Enforcement Delegated Report

EN23/0754

111 Frognal
London
NW3 6XR

Alleged Breach

Figure 3. As built section GG

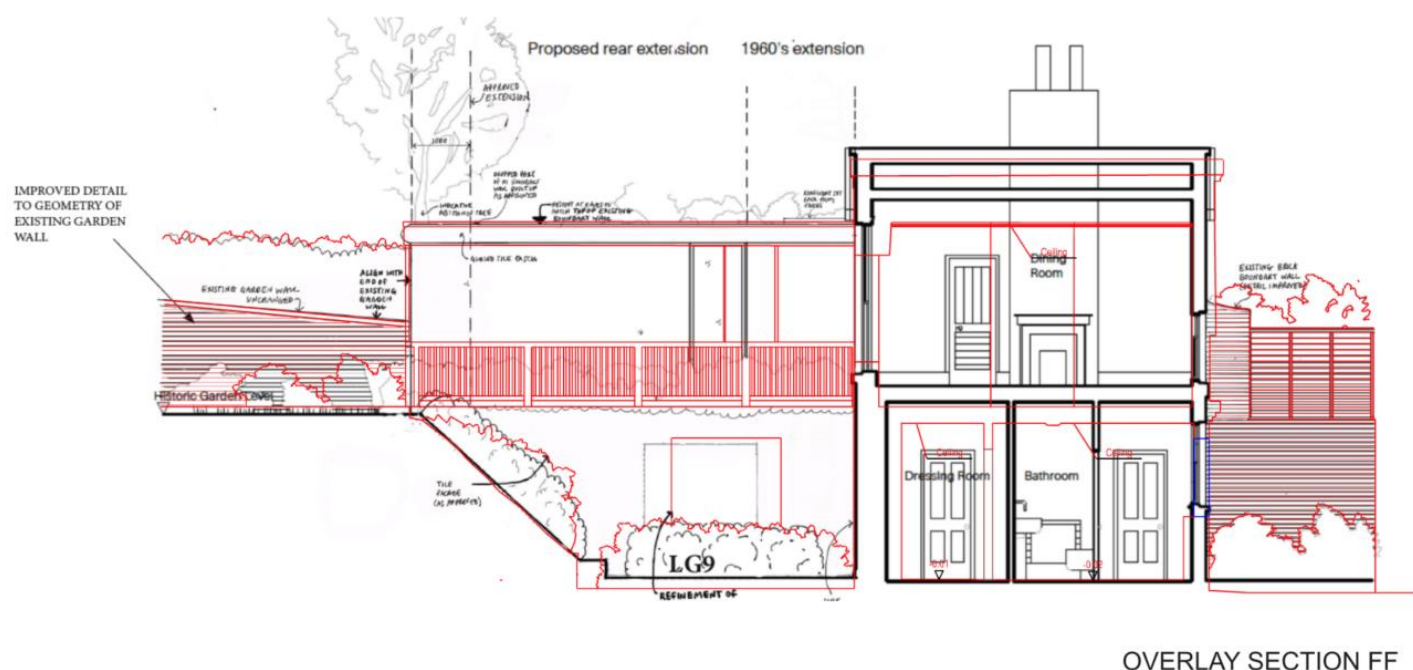
- Raising the height of the main roof ridgeline above the pre-existing ridgeline height, altering the pitch of the roof and bringing forward the position of the front roof slope.
- Increase in height of the front elevation so that the eaves position of the roof is higher
- Increase in height of the two front gabled projections.
- Front dormers have been built larger and in a different position.
- Rear dormer window has been built larger in size.
- Rear upper floor extensions have been built taller.

Figure 9. Site photograph showing the as built roof and firebreak

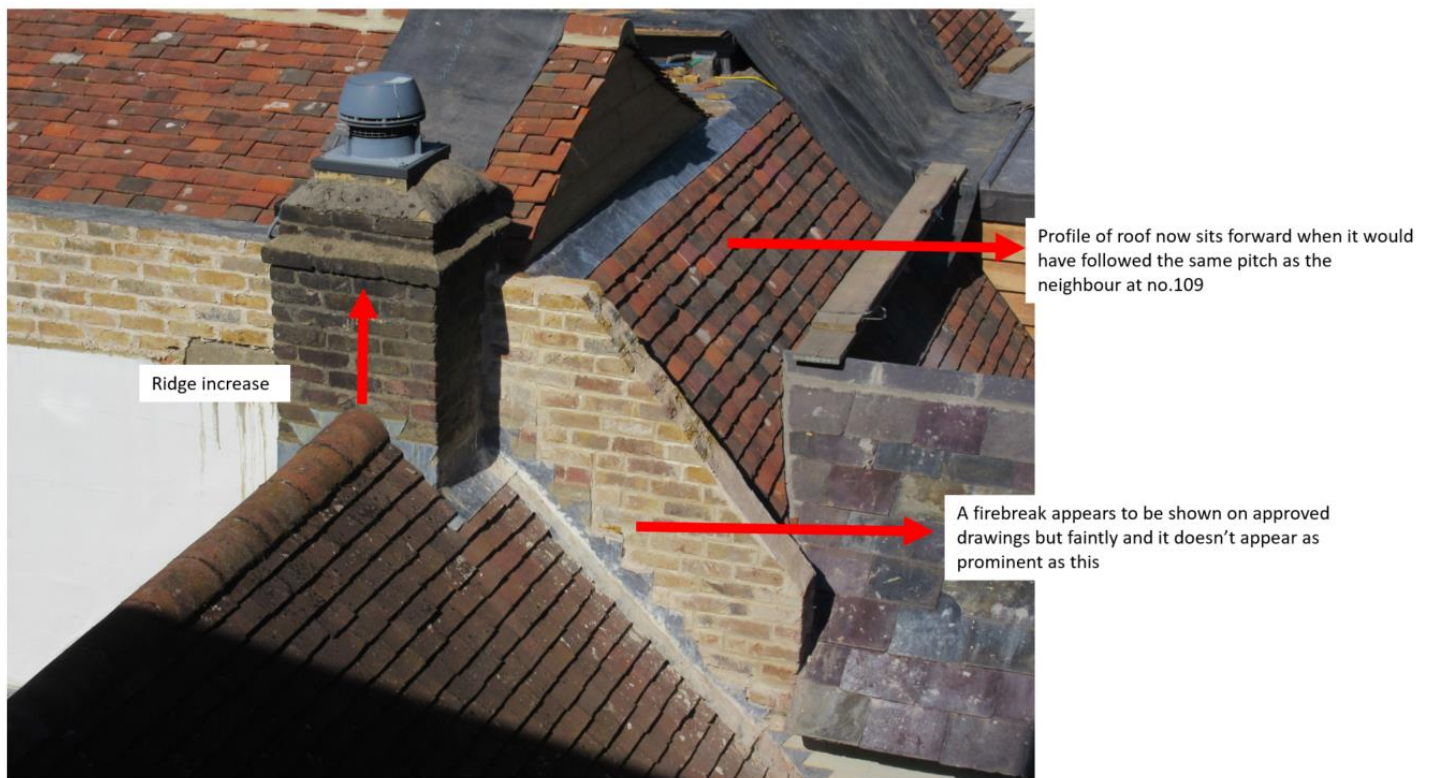
4.14 As the photos in figures 9 and 10 illustrate the alterations to the roof of no.111 are significant and unsympathetic and go far beyond the consents given. The roof on the front façade of the building has been completely demolished and rebuilt, without consent, with a higher ridge and a steeper pitch.

- .
- 4.23 The firebreak upstand as shown in Figure 9 was introduced to the drawings by the misleading means described above by introducing it in the elevation drawing for applications 2021/3072/P & 2021/3075/L with an annotation implying it was to accommodate approved changes as part of the parent applications 2019/6089/P and 2019/6100/L (when these changes were not approved). The firebreak upstand has been built higher than shown on the elevation drawing for 2021/3072/P & 2021/3075/L. It is a strongly inappropriate feature, dividing what was a single building into two very separate ones and dwarfing the chimney breast between the buildings as shown in figure 9 [and figure 17 below].

Figure 11. Approved front elevation drawing number E1.CC Rev.08 parent applications 2019/6089/P and 2019/6100/L

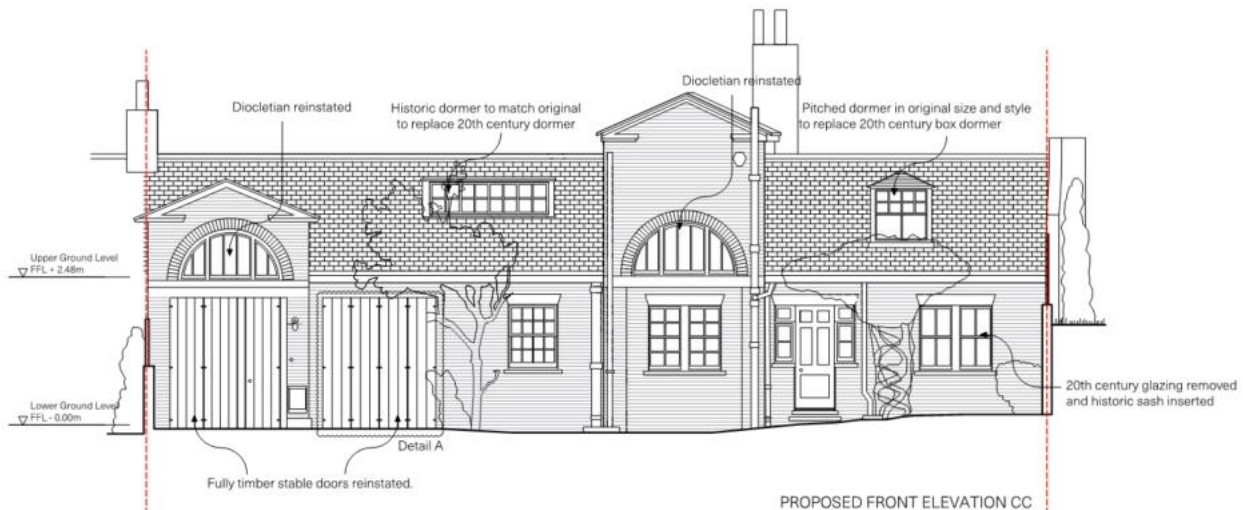
4.16 There is no increase in height to the roof ridge shown nor is it mentioned in anywhere else in the submitted documentation. The only alterations to the front roof is the removal of the insensitive front dormer windows and their replacement with more sympathetic dormers

Figure 13. Image showing the annotation on the above drawing which reads 'Proposed upstand in boundary wall to accommodation approved change in roof height'

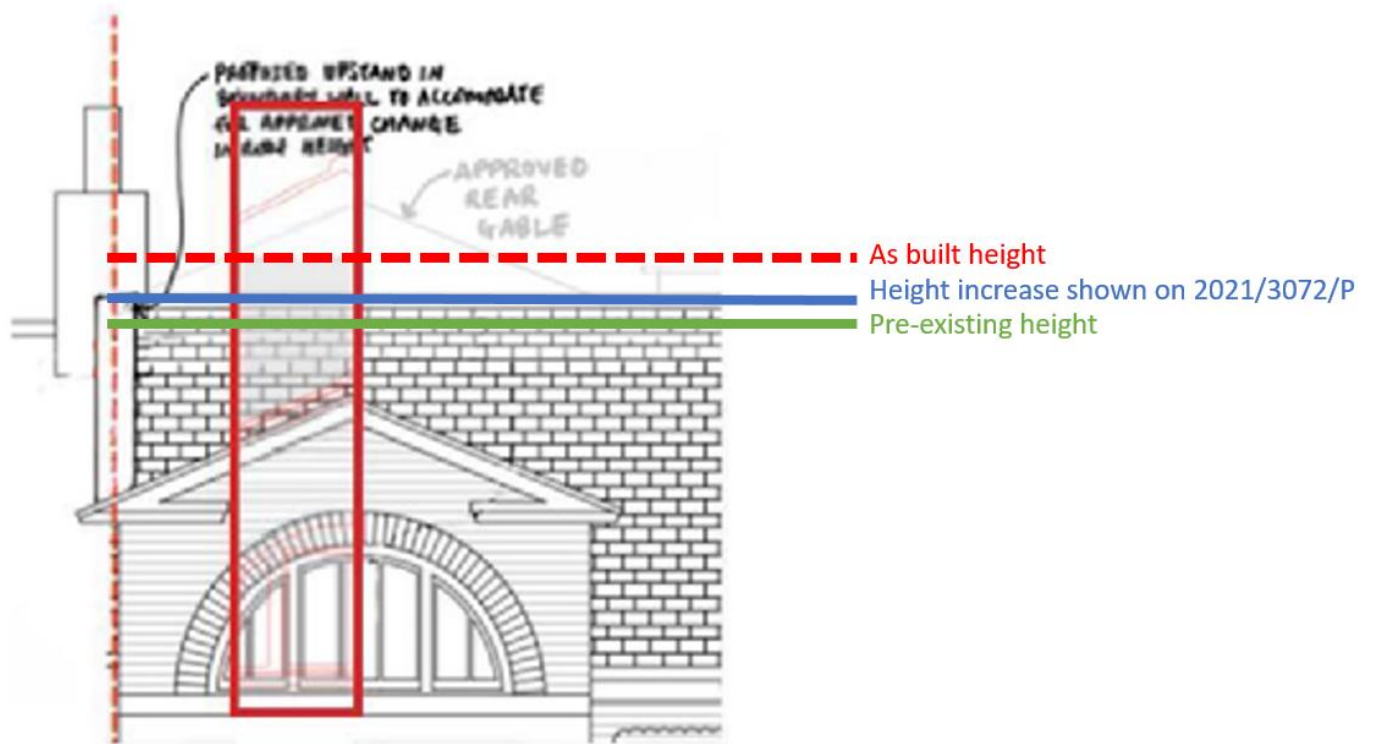
4.18 Aside from dormers to the front and rear the only alteration to the roof was the reinstatement of a pitched roof to the rear. The ridge increase shown on the one elevation drawing submitted under 2021/3072/P & 2021/3075/L (in figure 12 and 13) is inconsistent with and does not appear on any other approved drawings such as sections and nor is it mentioned anywhere else in the submitted documentation. Furthermore, there is no mention of this change within the development description. It is therefore considered that the increase in ridge height of the roof above the pre-existing ridge height is not approved.

4.19 Notwithstanding, even if the above annotation means an increase in ridge height has been inadvertently approved via applications 2021/3072/P & 2021/3075/L (which is disputed), it did not approve changing the pitch, profile, eaves and position of the roof. These elements have never been shown on any sections, and nor were they shown by the owner on the as built sections provided to the Council on 10th October 2023. In addition, the ridgeline shown in the elevation drawing would only be marginally higher than the adjoining neighbour at no.109 however as figures 9 and 10 show, the difference is substantial and they no longer read as one building. The difference in the as built height is further shown in Figures 13 and 13a.

Figure 14. Proposed sections provided as part of applications 2021/3072/P & 2021/3075/L.

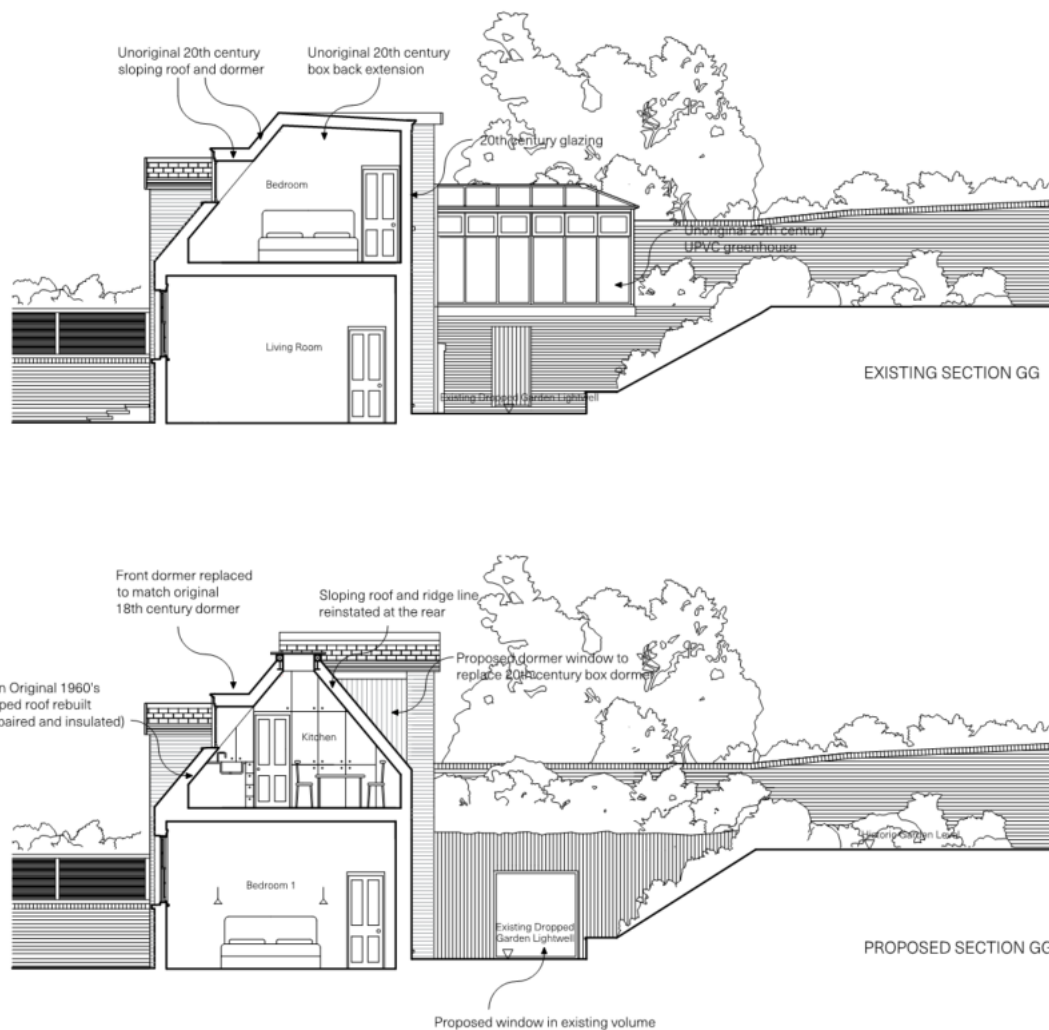
4.20 As the approved section above illustrates, only the rear roof slope was to be altered. On the 10th October 2023 the owner provided drawings to reflect the as built situation which included the section below. The section does not show the significant alterations to the front roof slope.

Figure 15. Sections provided by the owner on 10th October 2023 to show the as-built situation which does not show that the front roof has been bought forward.

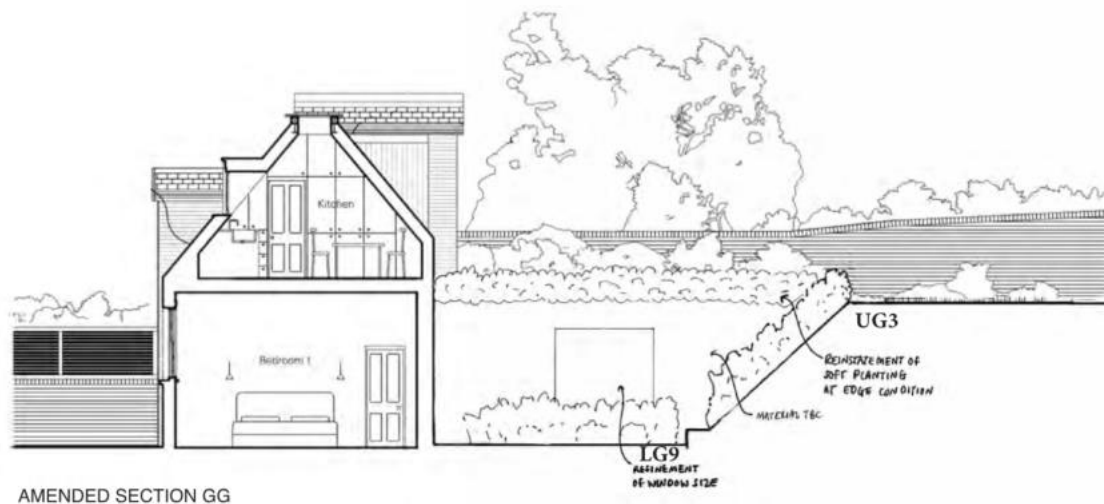
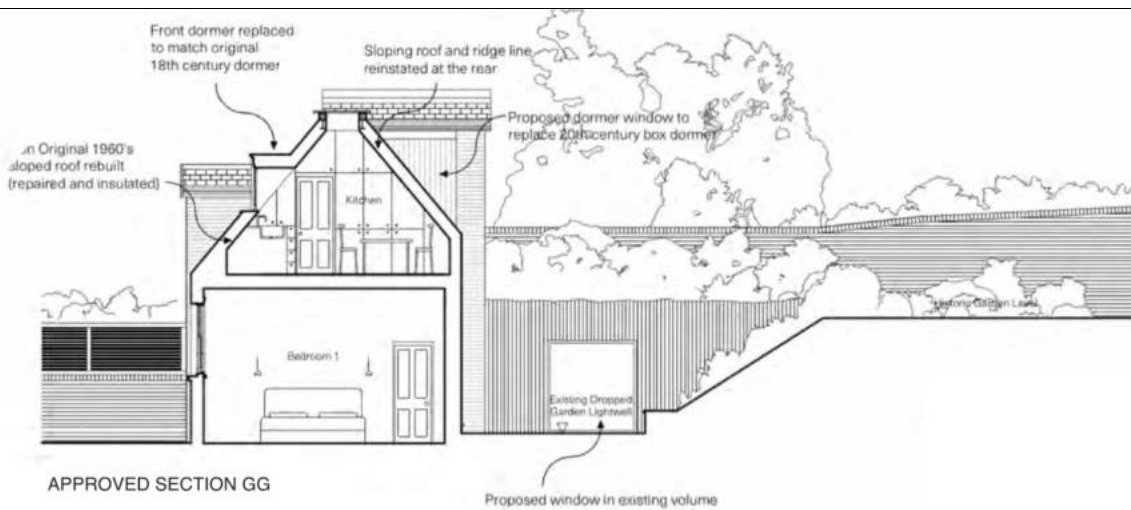
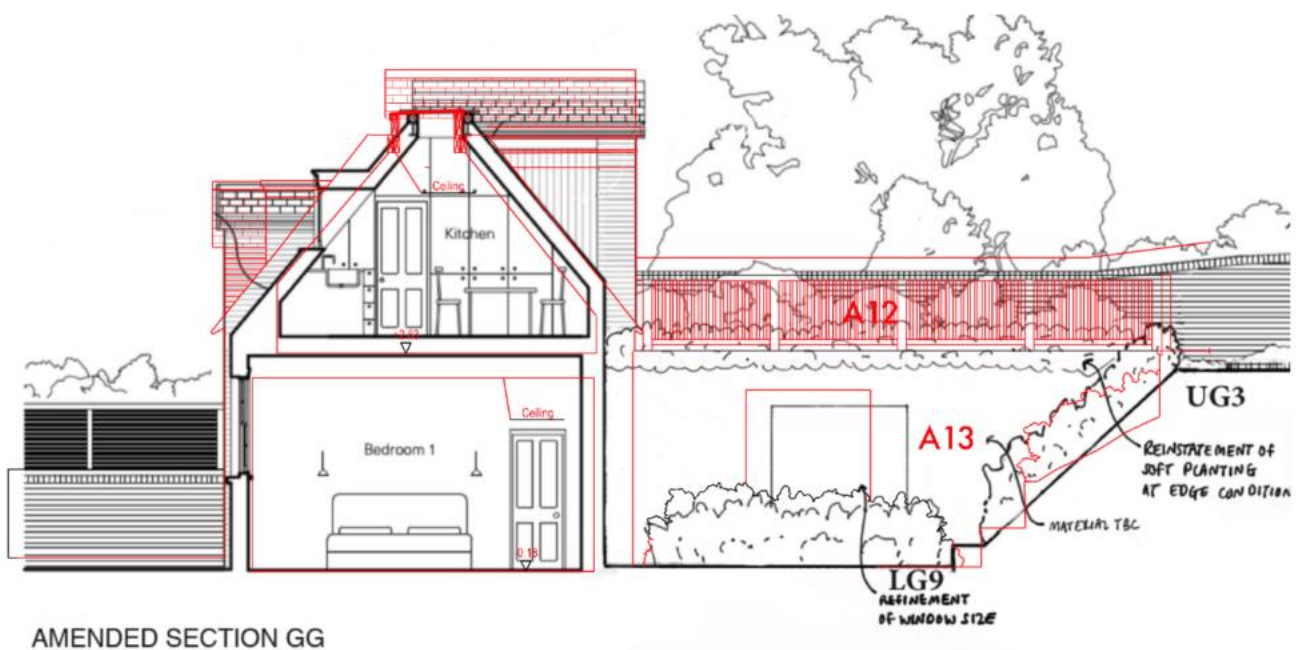
- 4.21 In June 2024, the above section at Figure 16 was provided by the owner's agent which shows in red the as built differences that the owner repeatedly failed to show on several drawing sets submitted to the Council throughout their application stage and enforcement investigation.

Figure 17. As built elevation showing increased height in firebreak and ridge height as compared to proposed front elevation submitted as part of applications 2019/6089/P and 2019/6100/L and 2021/0409/P and 2021/0406/L

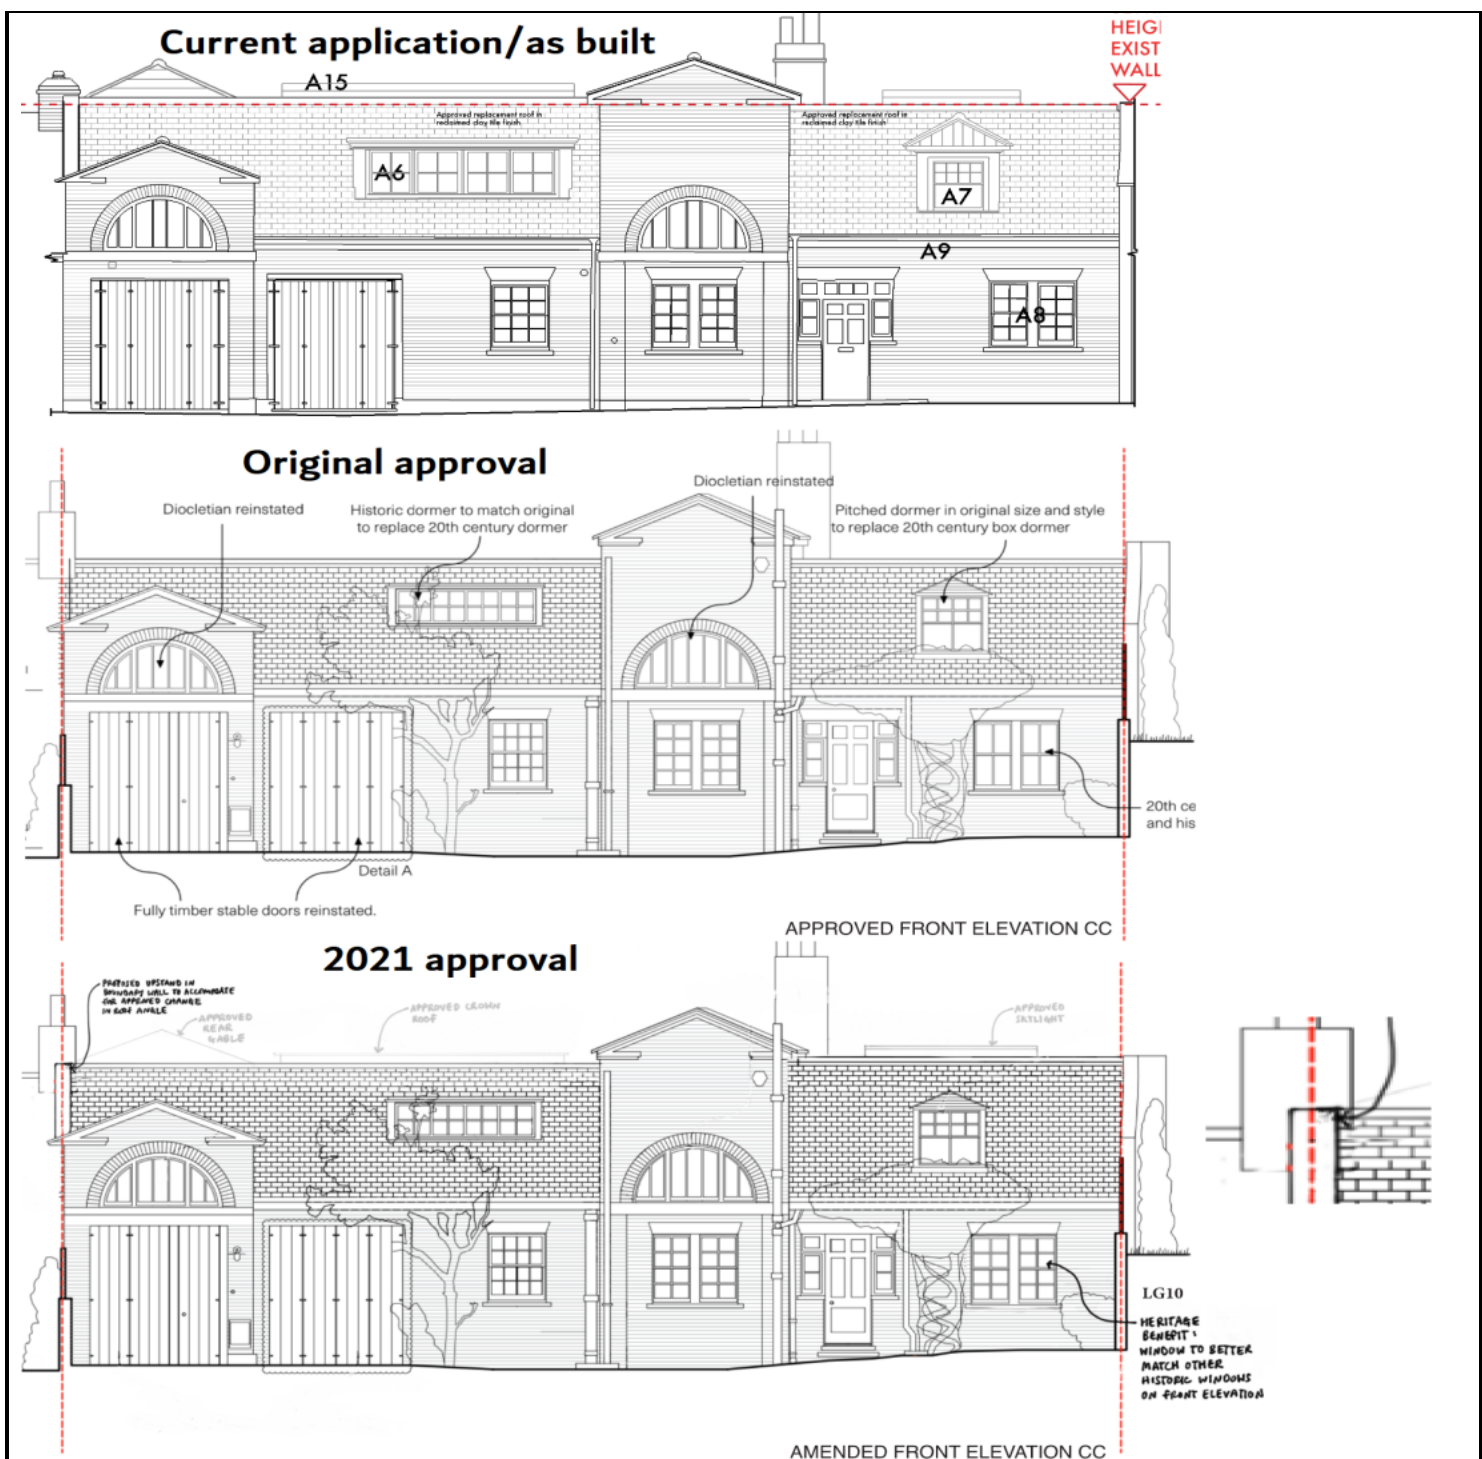
4.24 The roof abutting no.113 has also been substantially altered in pitch. The pre-existing roof stood off the curved capping stones by around two bricks' lengths; it now abuts the capping stones such that the once prominent curved capping stones that added to the aesthetic quality afforded by the dwelling is much less noticeable, being largely obscured by the newly brought forward roof (shown in figures 20 and 21 below). In addition, it was at an approximately a 45 degree pitch, but is now steeper.

Figure 19. 1. Pre-existing front elevation, 2. Proposed front elevation 2019/6089/P and 2019/6100/L, 3. Proposed front elevation as part of 2021/3072/P & 2021/3075/L, 4. As built front elevation provided by owner on 10th October 2023

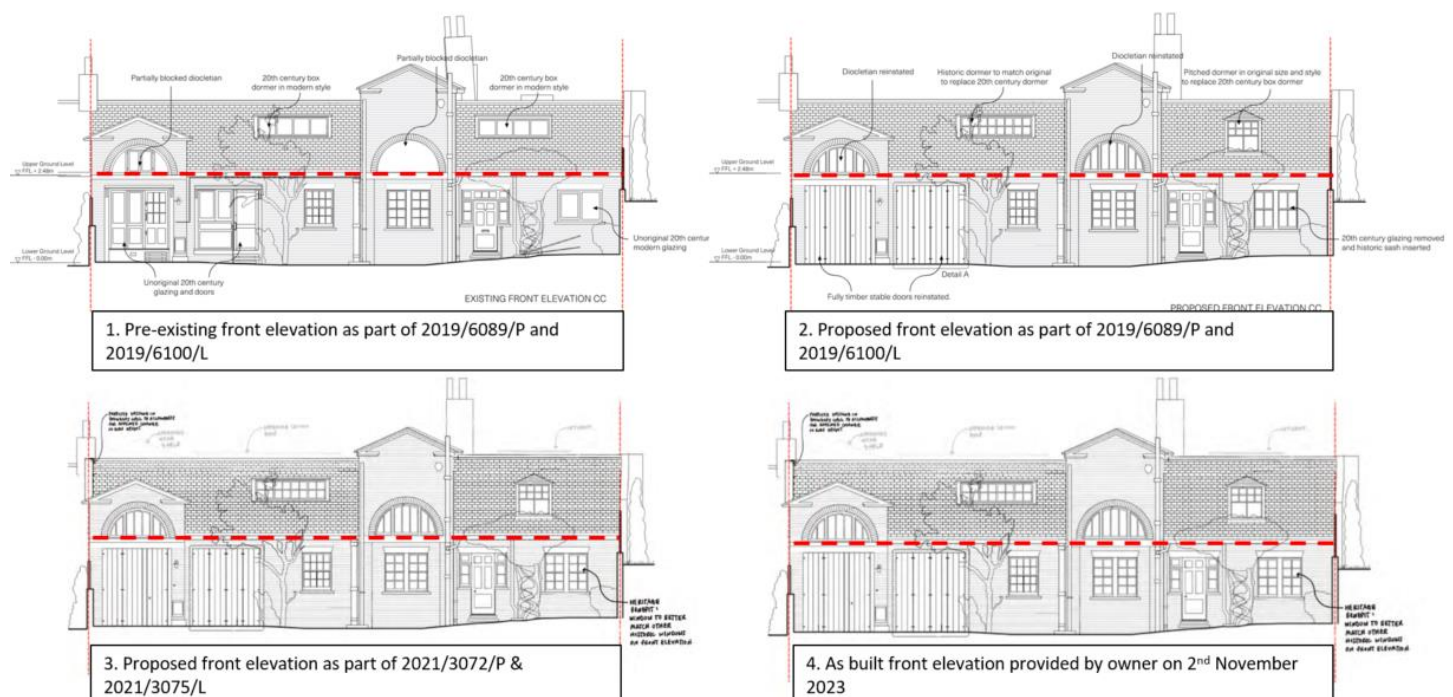
4.30 As the front elevations above show, the eaves of the roof have been illustrated as unchanging from the pre-existing elevation through to the as built front elevation provided by the owner on 10th October 2023. The altered position of the eaves was not shown by the drawings provided by the owner until 19th June 2024 as shown below in Figure 1.
